LAND USE - ZONING REPORT

ADDRESS: 256 Veranda St DATE: 4/24/98

REASON FOR PERMIT: INSTALL Siding, deck & doors

BUILDING PERMIT REPORT

FRONT view

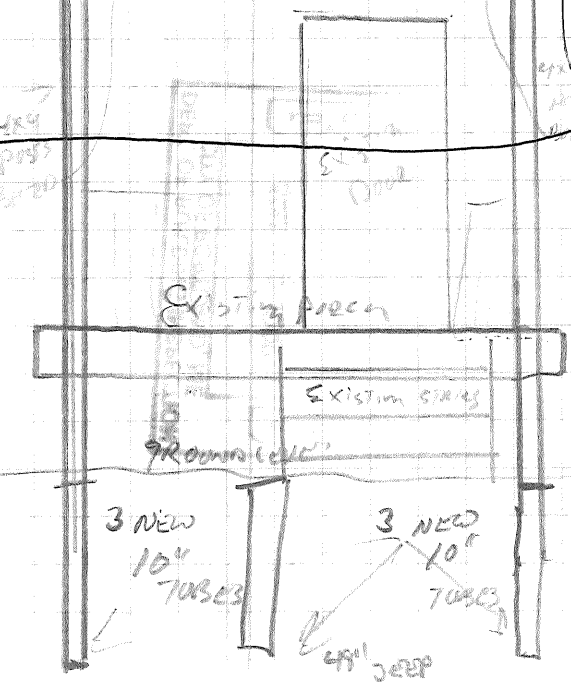
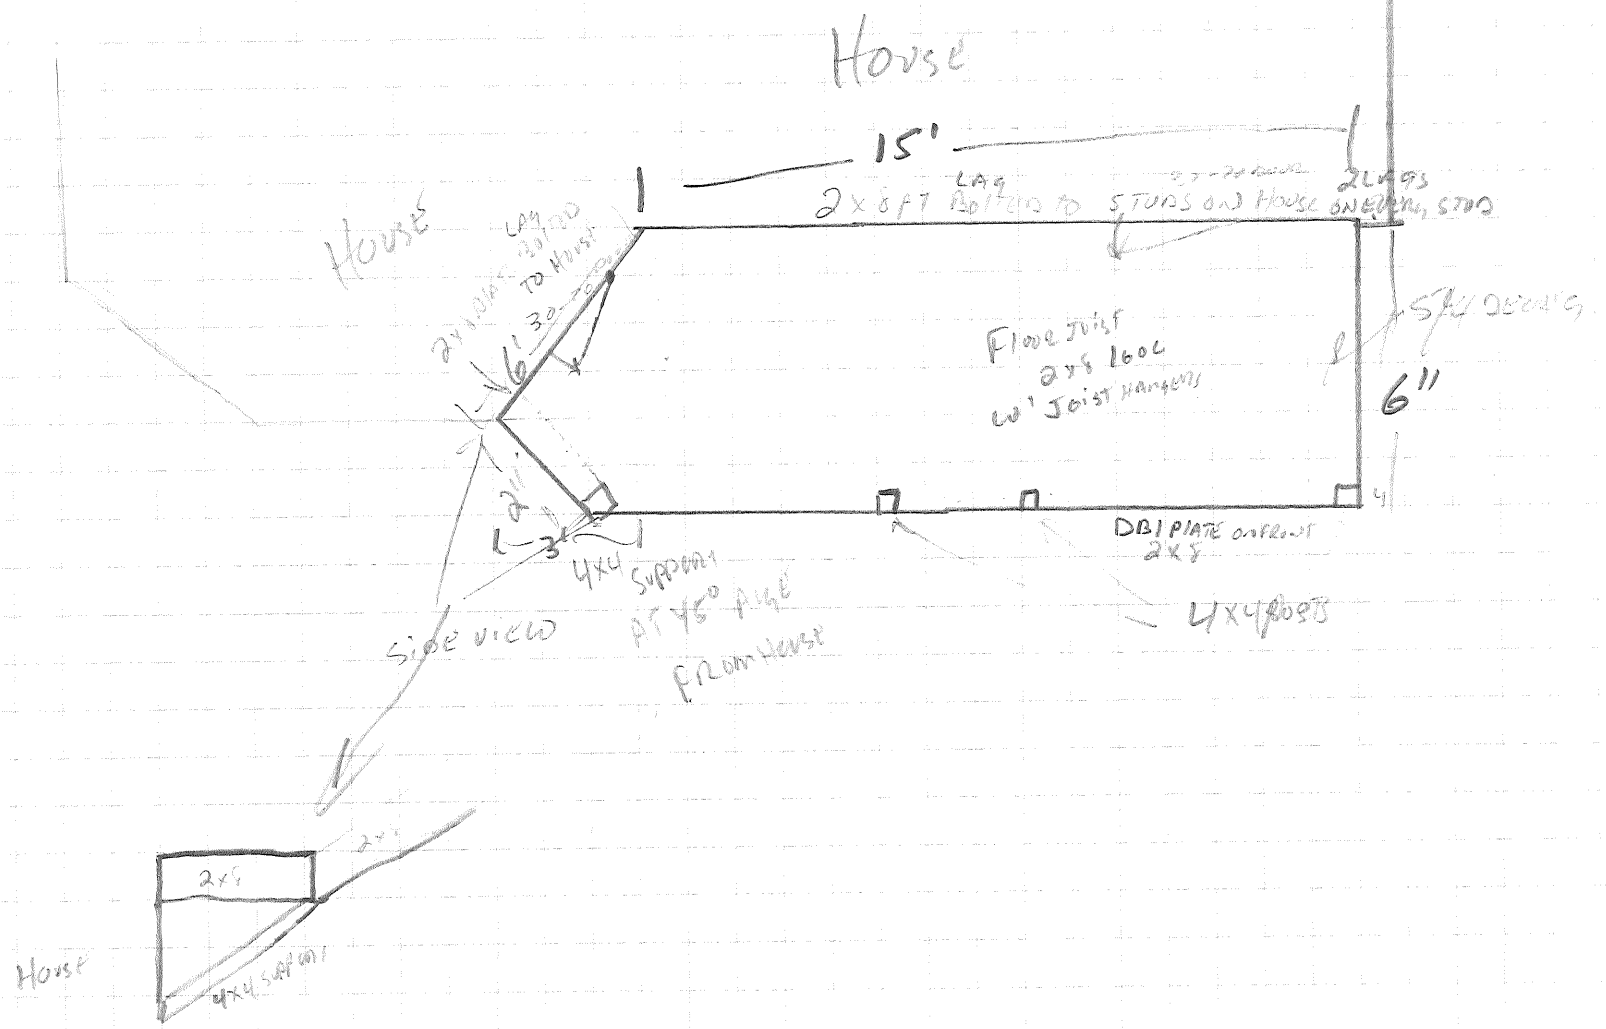
10. This deck shall not project closer to the street line than the existing entry way

- *29. The proposed 10" Sono Tubes must be placed on Footings with anchor between same.
- *30. IF the existing siding is asbestos and it's being removal you should call DEP on Carlio Rd. P.L.D. 887-7829 For removal instructions.
MR. Ed ANTZ. 287-7829
